Shelburne Beach House Project
407 Beach Rd., Shelburne, VT 05482
Town of Shelburne RFI Response
Feb. 3, 2023

Project: Shelburne Beach House
407 Beach Road
Shelburne, Vermont 05482

Submittal: RFI Responses: Bid Drawings Dated 12/19/2022

Rush Meadow Consulting (RMC) Project # 1052

1 FIRST FLOOR POWER/TELCOM PLAN
1/16/23

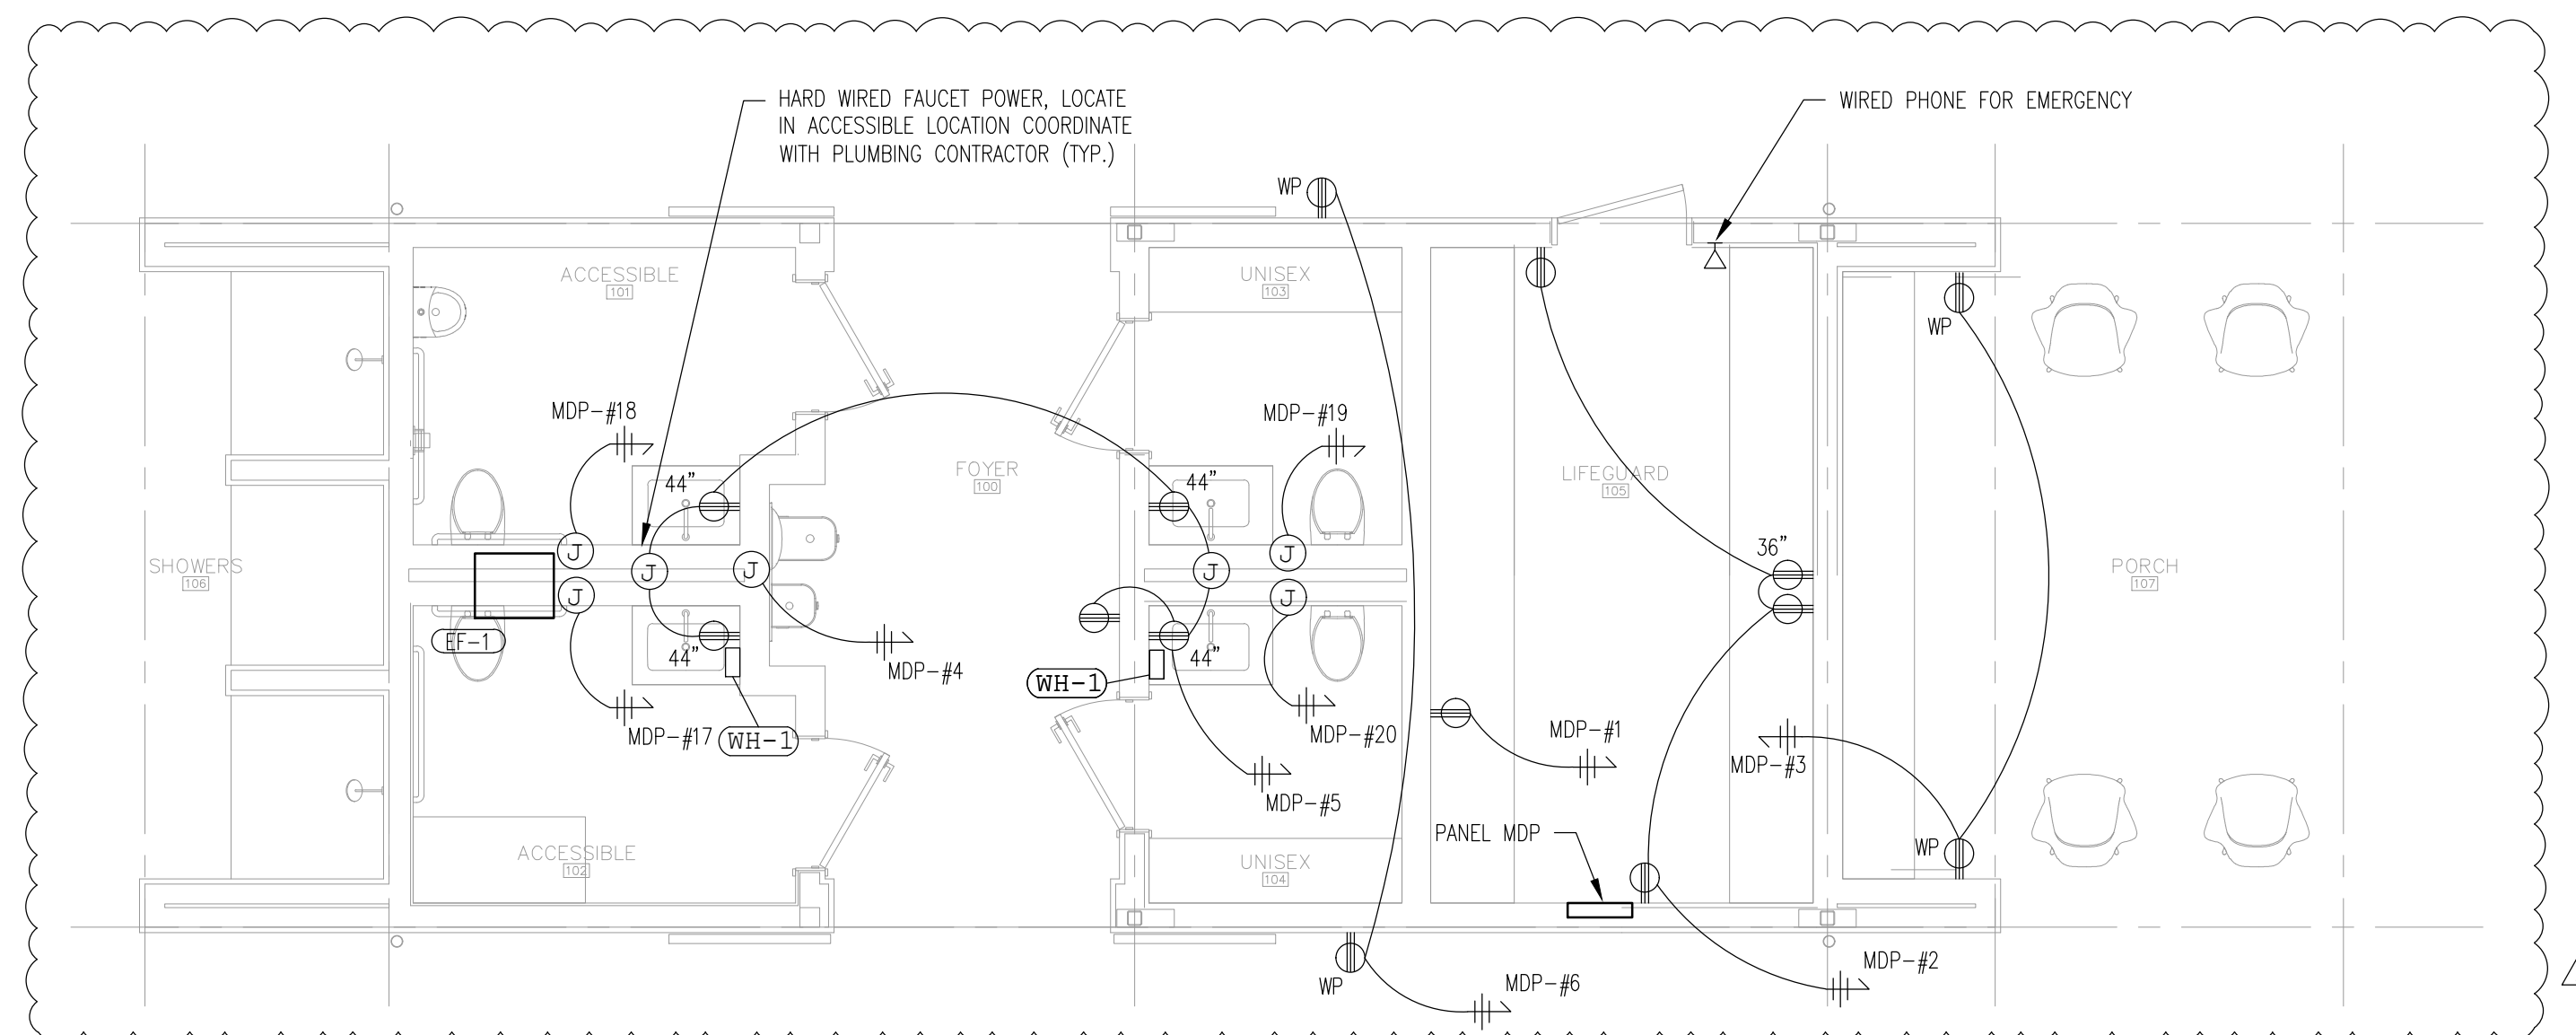
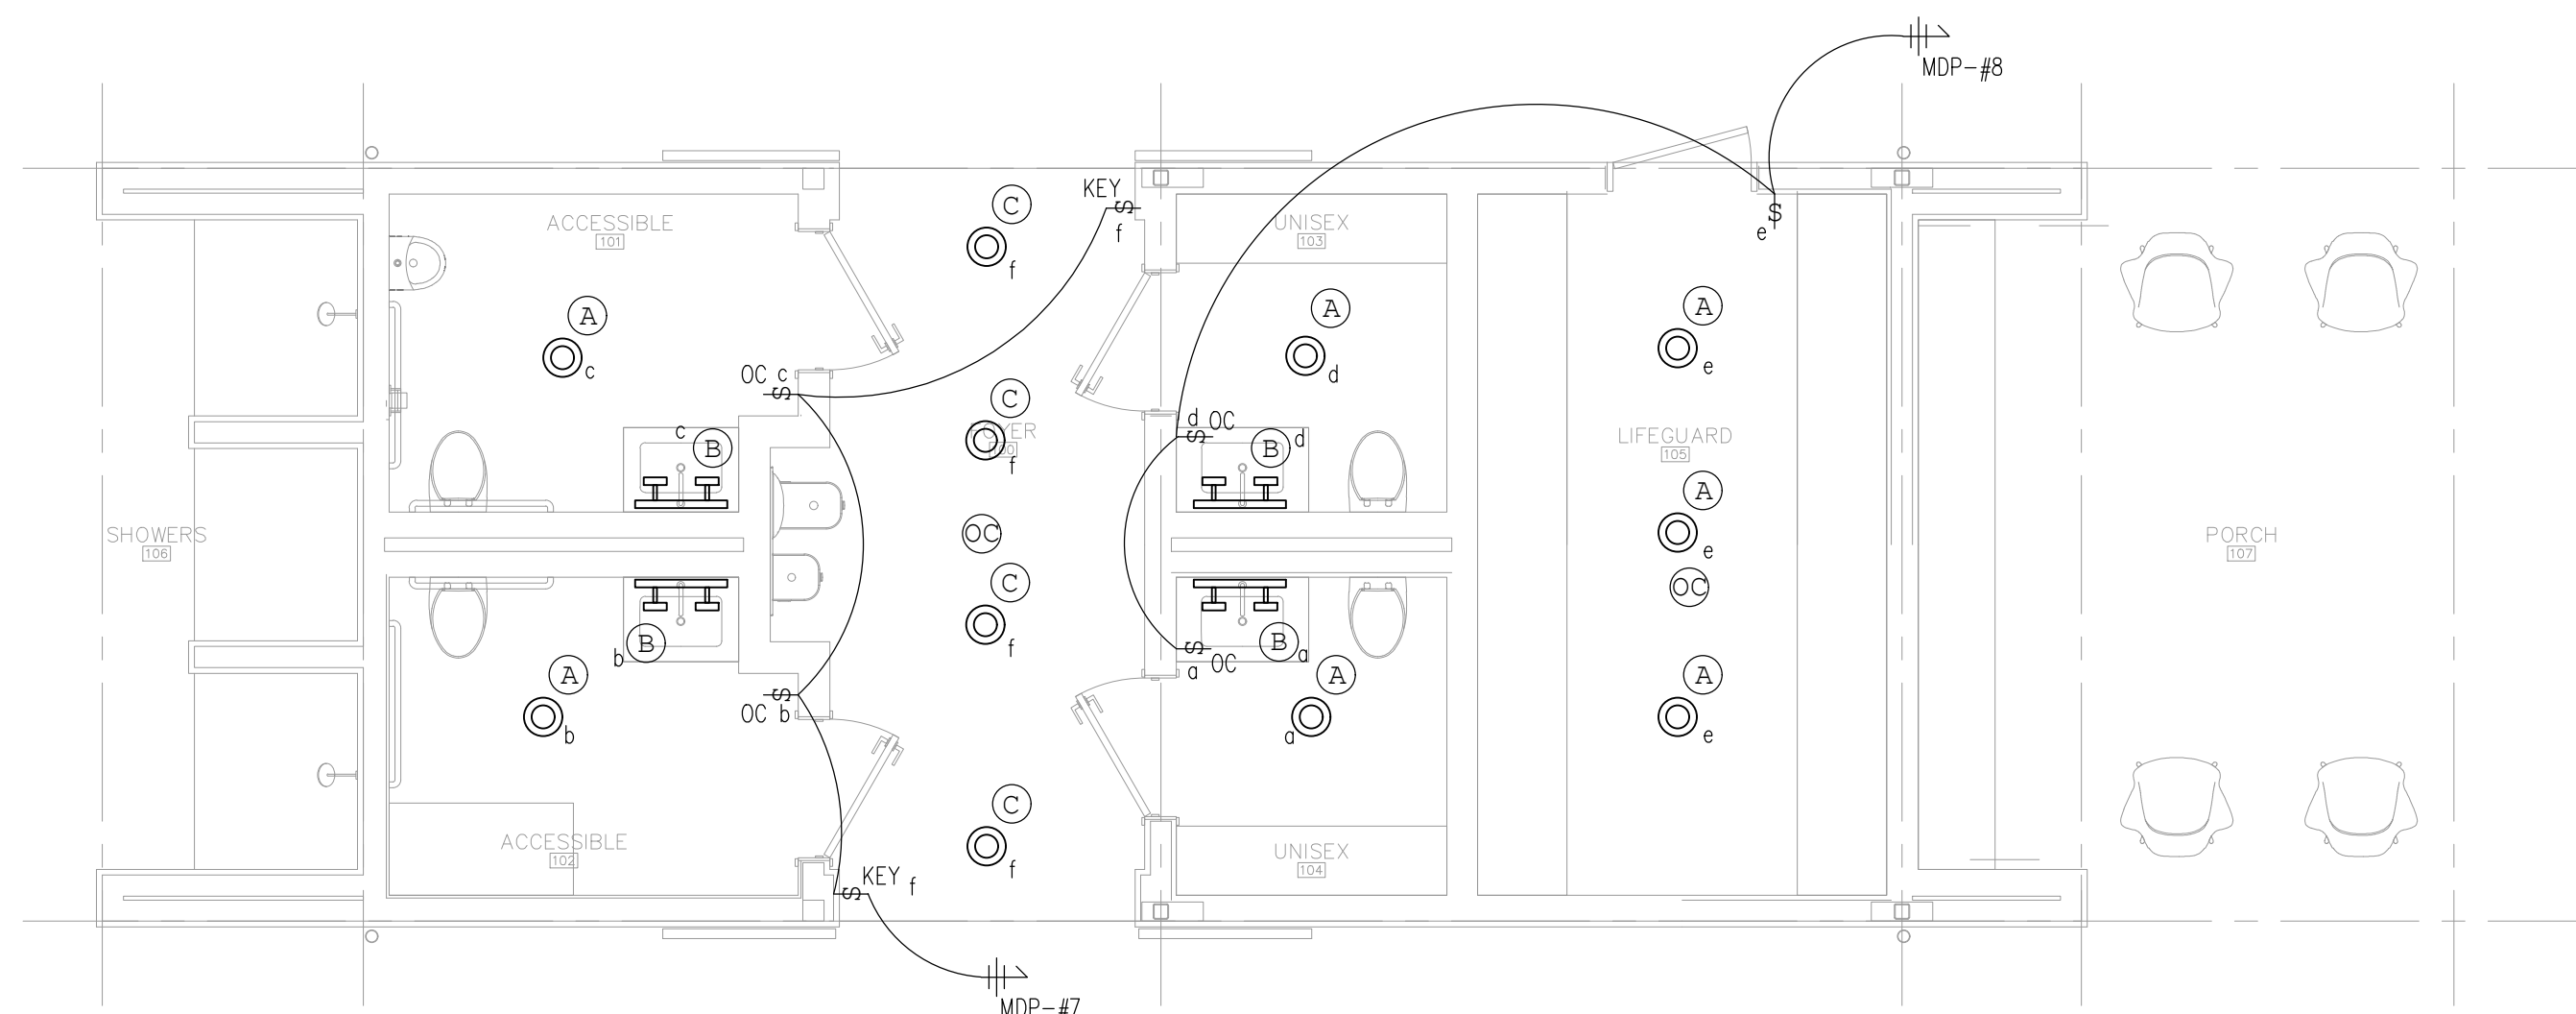
1. CO and Smoke detectors are not rated for low temperatures.

4. Drawing E1.10. lifeguard room 105. Since the electric panel is in this room, the ceiling occupancy sensor shown in this room is a NEC code violation, article 110.24D. This sensor should be removed from the project. Correct?

5. details on drawing A-105 indicate hand dryers in restrooms. Electric drawing E1.10 plan and panel schedule does not indicate any hand dryers. Please clarify.

Response: No smoke detection or CO will be required. At this time, no Fire Protection devices will be installed unless required by the town of Shelburne. Updated drawings indicate the removal of all FA devices. Reference updated E1.11 attached.

Response: Occupancy sensor is efficiency code required. If deemed to be in violation we will work with local AHJ to be removed. For bidding purposes OC sensor remains in room.

Response: Hand dryer junction boxes and circuits have been updated on electrical plans to match architectural. Reference updated E1.10

1 ELECTRICAL ONE-LINE
1/16/23

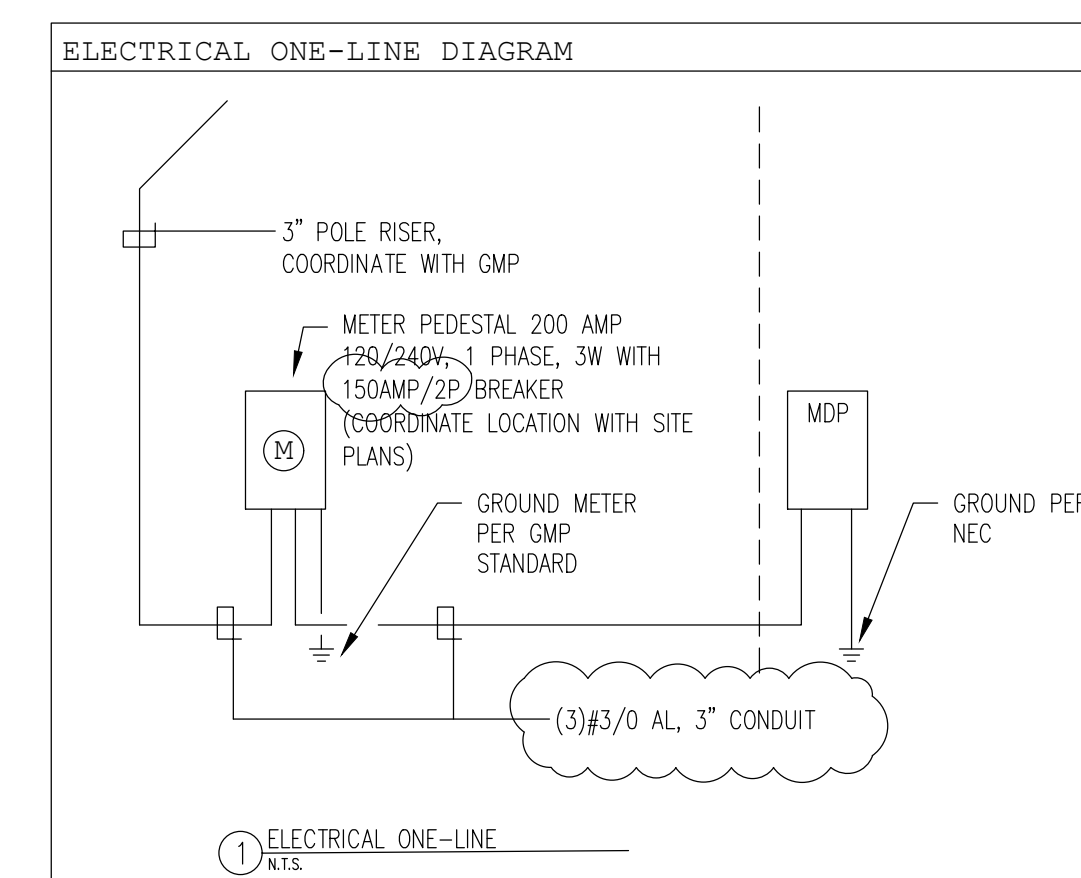
6. There seems to be a conflict between electrical and plumbing drawings regarding the water heaters (WH-1). Electric drawing indicate a 120 volt 20 amp circuit to each water heater. Drawing P5.01, the "WH-1" model number represents a 13KW 240 volt circuit per heater. Please clarify.

Response: Water heater model has been revised to HA008240 8 KW and 40 Amp 2 Pole breaker and 2-#8, 1#10G, 3/4" conduit for each water heater provided.

Electrical service size feed has increased in size.

MDP Panel size has increased to 225 Amp.

1 TRUSS LEVEL MECHANICAL PLANS
TYPE 9

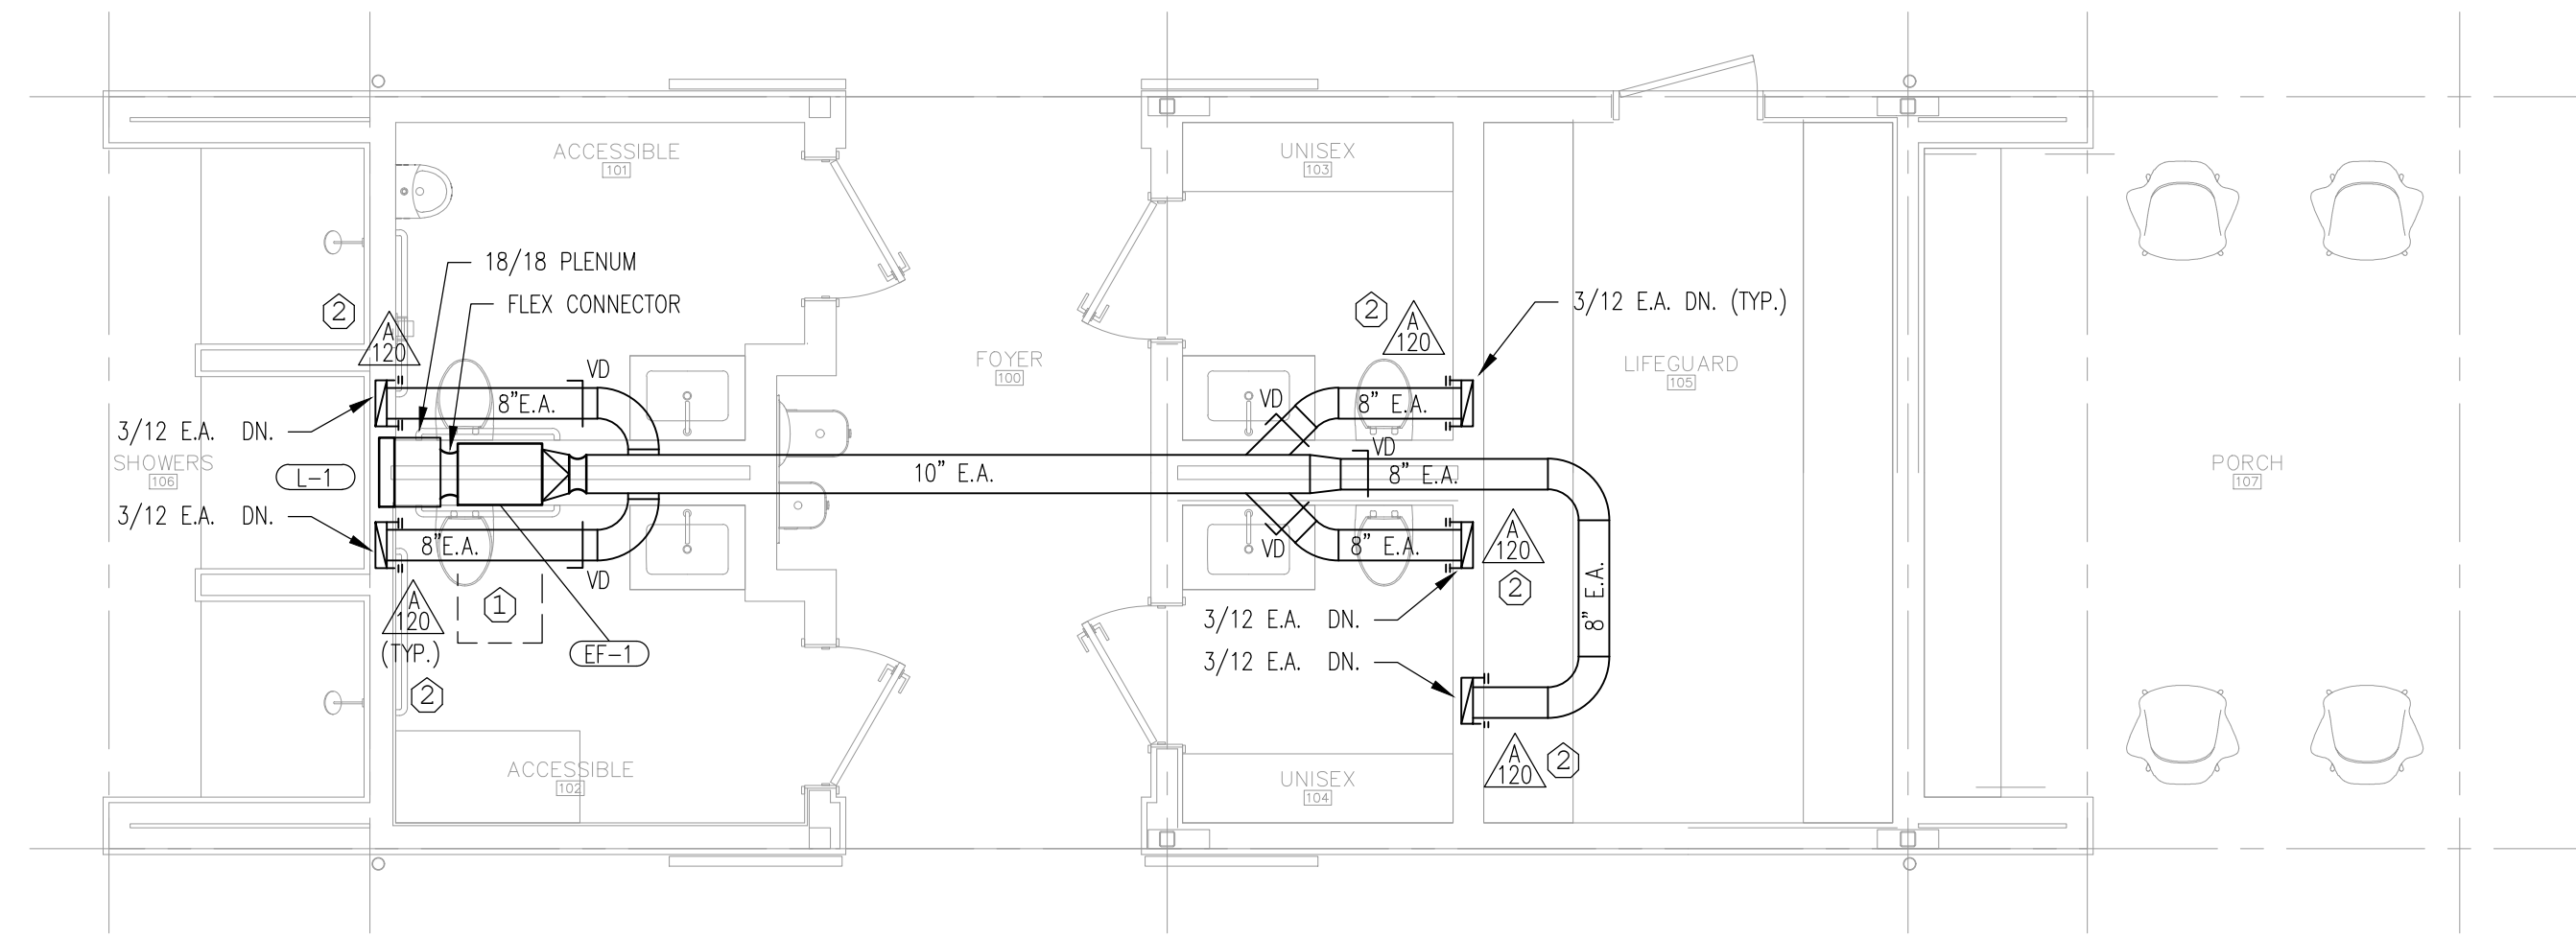
3. L-1 tagged on M1.10, but not scheduled, need selection # and dimension.

Response: Provide Greenheck EDJ-401-18x18 louver. Reference updated mechanical plan M1.11 attached.

Louver size and specification have been provided.
